From: Terry Scanlan <TScanlan@spfwater.com>
Sent: Friday, June 02, 2017 5:25 PM
To: Nelson, Dan
Cc: rmooney@shorelodgemccall.com; Lori Graves
Subject: RE: Sabal Whitetail Permits.

From: Nelson, Dan [<mailto:Dan.Nelson@idwr.idaho.gov>]
Sent: Thursday, March 2, 2017 3:30 PM
To: Lori Graves <LGraves@spfwater.com>; Terry Scanlan <TScanlan@spfwater.com>
Subject: Sabal Whitetail Permits.

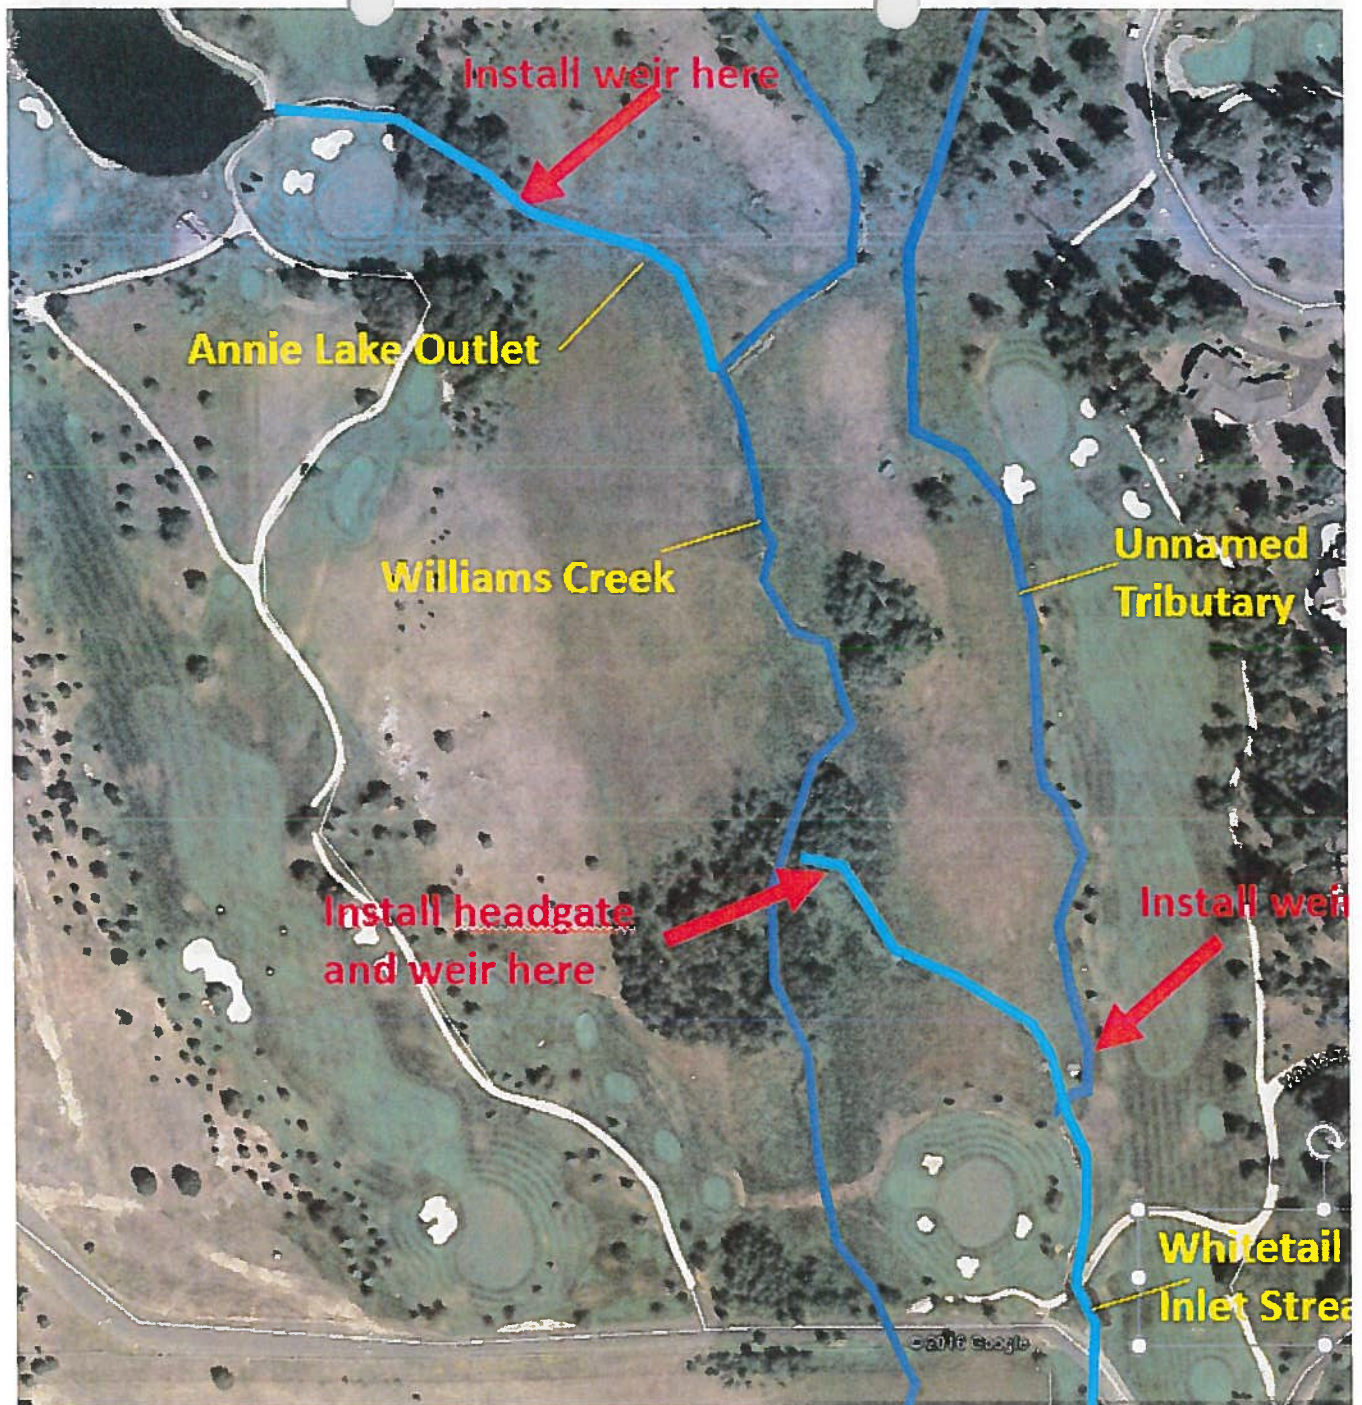
3. **65-2911 Diversion of Williams Creek.** I walked Williams Creek in the reach where the water from Annie Lake flows through to Whitetail Lake. My recommendation is to (1) install a weir on the Annie Lake outlet stream, and (2) install a weir and headgate on the inlet stream to Whitetail Lake just downstream from the bifurcation from Williams Creek.

There is also an unnamed stream tributary to Williams that flows to Whitetail Lake inlet stream; it appeared to be flowing less than 0.05 cfs on Tuesday. A weir can be placed on this stream also if necessary.

Williams Creek Issue -- I think the weir on the outflow of Annie Pond and the installation of a headgate and a weir/measurement device at the point of rediversion from Williams Creek is reasonable. I also agree that the installment of a weir on the unnamed stream would give the watermaster the opportunity to regulate all three sources once the new applications for permit are approved. Until then, they could subtract unnamed stream amount from the water diverted at the point of rediversion to insure they are not diverting water to the pond that isn't authorized by a water right.
